ANEFCO INC. 222 Memoroneck Avenue
White Plains, New York 10605

Subject: ANEFCO AP-101 Cask Supplement

AMENDMENT TO ANEFECO, INCORPORATED
SAFETY ANALYSIS REPORT
CASK AP-101
SECTION 6 CRITICALITY
SECTION 7 OPERATING PROCEDURES
MAY 15, 1980

FIG 1.6 TYPICAL FUEL BASKET CONFIGURATIONS

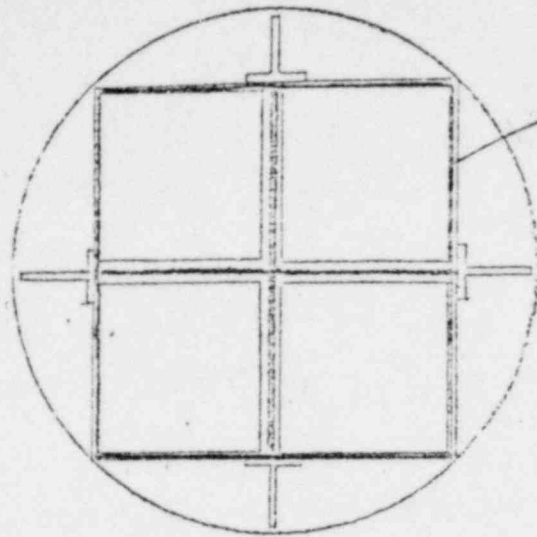
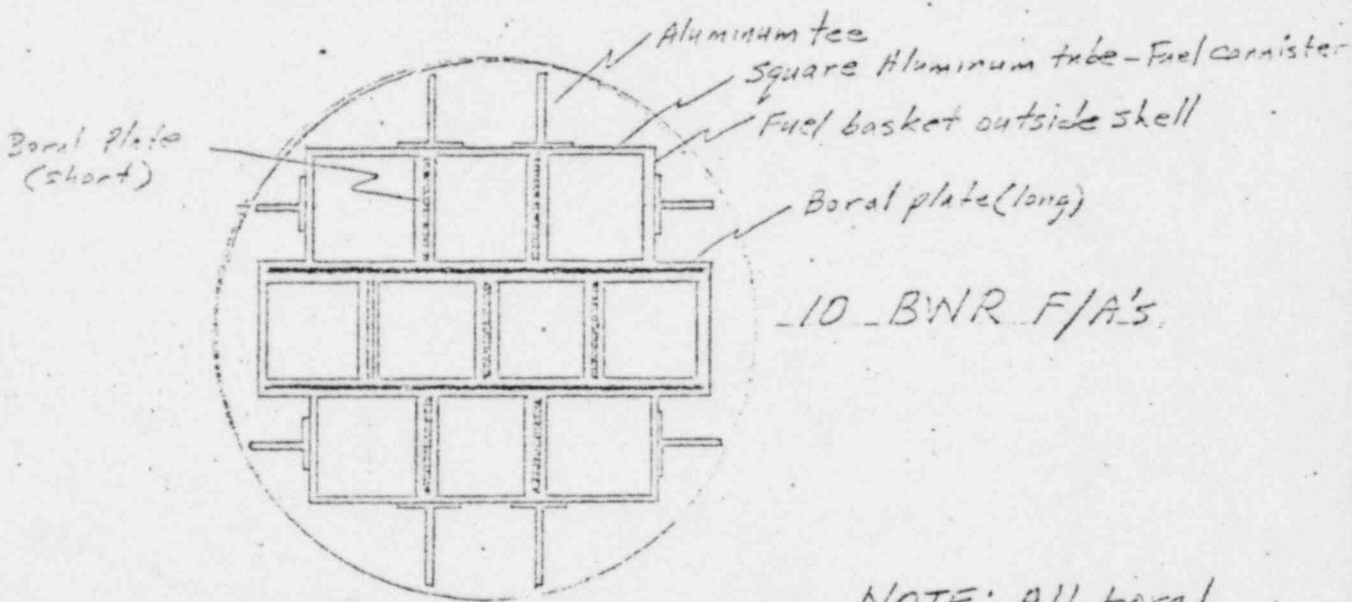
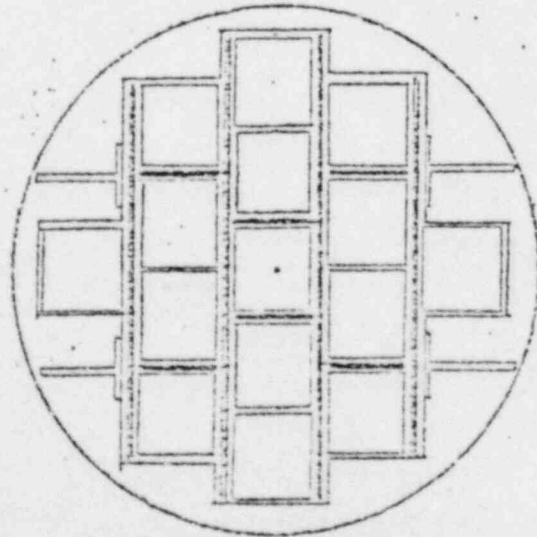
While the earlier submittal of December 20, 1979 indicated in Figure 1.6 (page 1-17) and on page 1-18 that 1/4" thick boral plates would be used for criticality control, we have added 1/8" thick plates of boral to the spent fuel basket design for PWR fuel. Revision A sheets for Figure 1.6 and page 1-18 are attached which incorporate that design modification.

$\frac{1}{8}$ " boron plates (4) (A)

NOTE: All boron plates $\frac{1}{4}$ " thick except as noted. (A)

Boral plates of nominal 1/4" and 1/8" thickness are used in the fuel baskets to provide criticality control. As noted in Figure 1.6, some of the plates will traverse the full width of the fuel basket in order to provide a conduction path for heat transfer from interior spent fuel assemblies. The boral plates will be affixed to the fuel cannisters with flat steel bands. The long boral plates will be banded to several fuel cannister tubes. Short boral plates will be banded to a single fuel cannister. (A)
